ECONOMIC COMMISSION FOR EUROPE

Working Party on the Construction of Vehicles

REVISED PROPOSAL FOR DRAFT 06 SERIES OF AMENDMENTS TO
REGULATION No.14
(UNIFORM PROVISIONS CONCERNING THE APPROVAL OF VEHICLES WITH
REGARD TO SAFETY-BELT ANCHORAGES)

Transmitted by the French Delegation

Figure 1 : Static force application device (S-FAD), isometric views

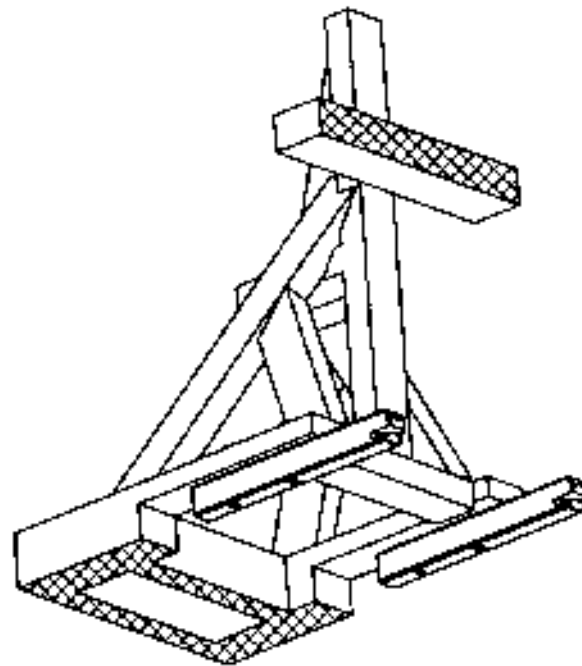
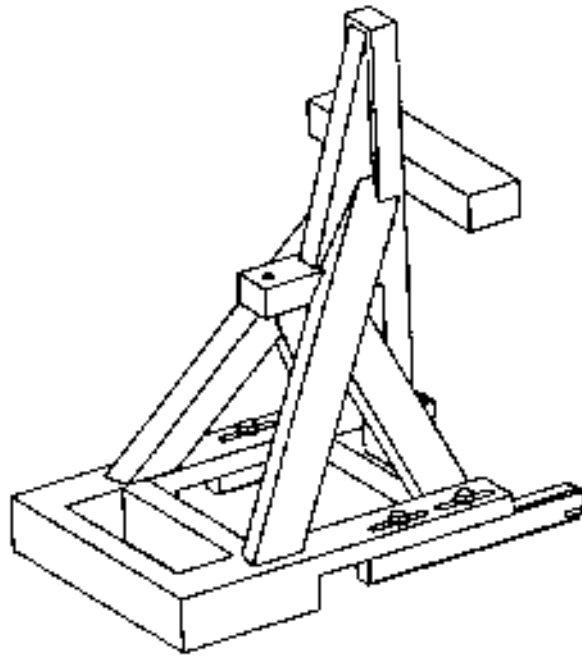
2.22. “Static force application device (S-FAD)”
means a test fixture that engages the vehicle ISOFIX anchorage system and that is used to verify their strength and stiffness in a static test. The test fixture is describe in the figures 1 and 2.

6.6.1. *The strength of the ISOFIX anchorage systems shall be tested applying the forces, as prescribed in paragraph 6.6.4., to the static force application device (S-FAD) with ISOFIX attachments well engaged. In case of several ISOFIX anchorage systems are installed on a seat row, the test shall be carried out simultaneously with all the ISOFIX anchorage systems fitted on this seat row.*

Figure 2 : Static force application device (S-FAD), dimensions

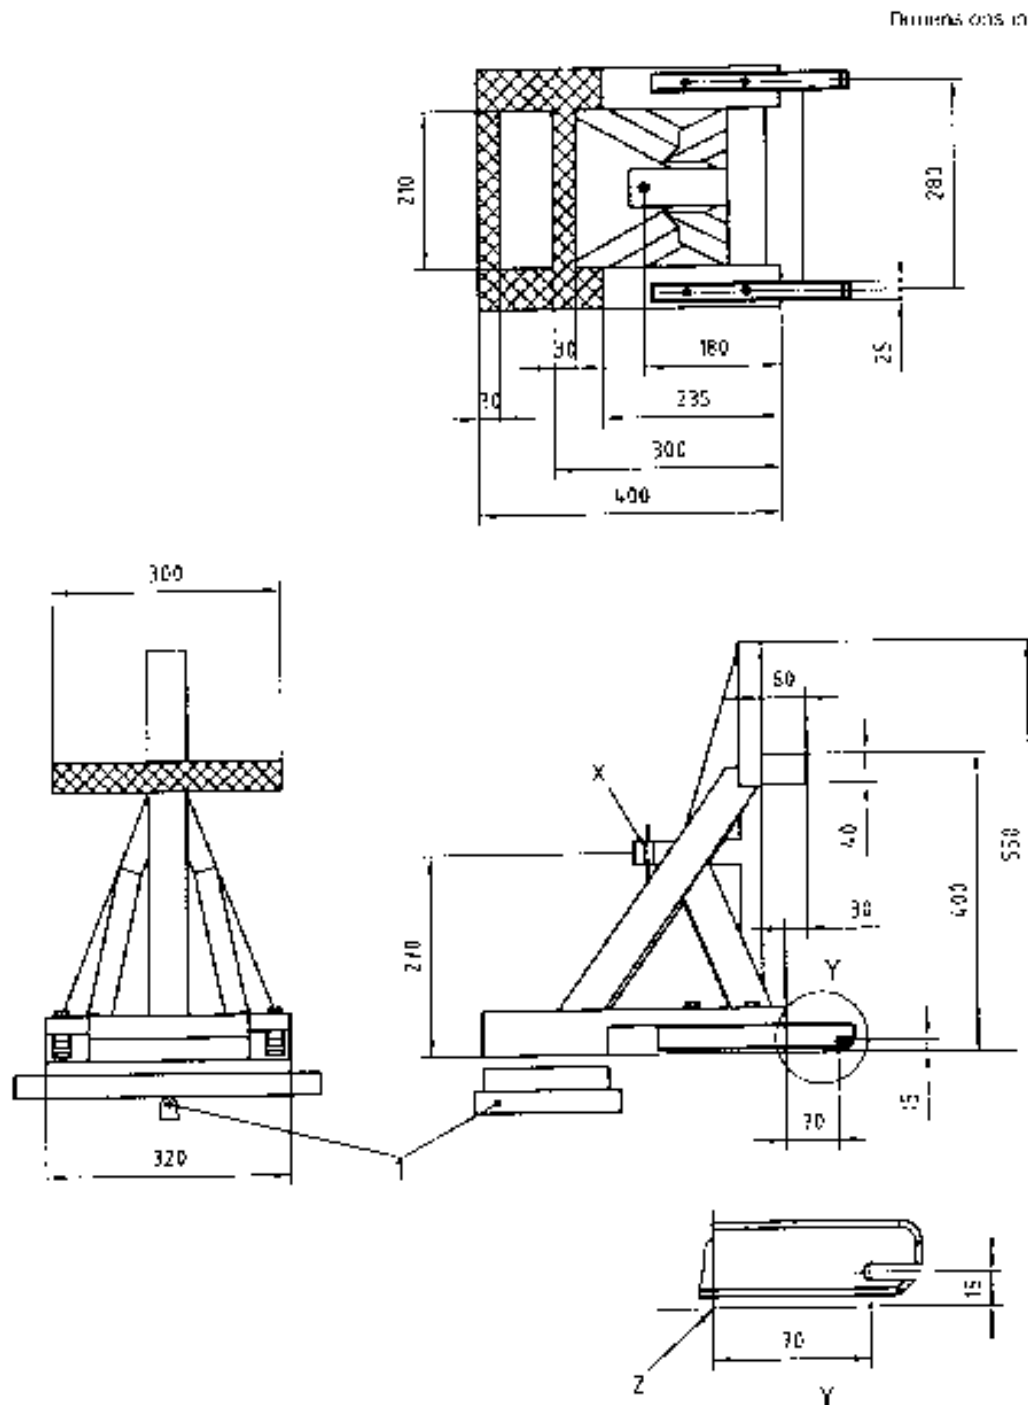
Stiffness of S-FAD : When attached to rigid anchorage bar(s) with the front cross member of the S-FAD supported by a rigid bar that is held at the centre by a longitudinal pivot 25mm below the S-FAD base (to allow bending and twisting of the S-FAD base) the movement of point X shall not be greater than 2 mm in any direction when forces are applied in accordance with table n°1 of paragraph 6.6.4. of this regulation. Any deformation of the ISOFIX anchorage system shall be excluded from the measurements. The stiffness requirements will be fulfilled when using a securely welded construction consisting of rectangular 3mm steel tubing, and 6mm thick load application plate.

Forces in the forward direction shall be applied with an initial force application angle of 10 \pm 5° above the horizontal. Lateral forces shall be applied horizontally 0° \pm 5°. A pre-load force of 500 N \pm 25 N shall be applied at the prescribe loading point X indicated in figure 2. Full application of the force shall achieved within a period of 2 s or less. The force shall be maintained for a minimum period of 0,2 s.
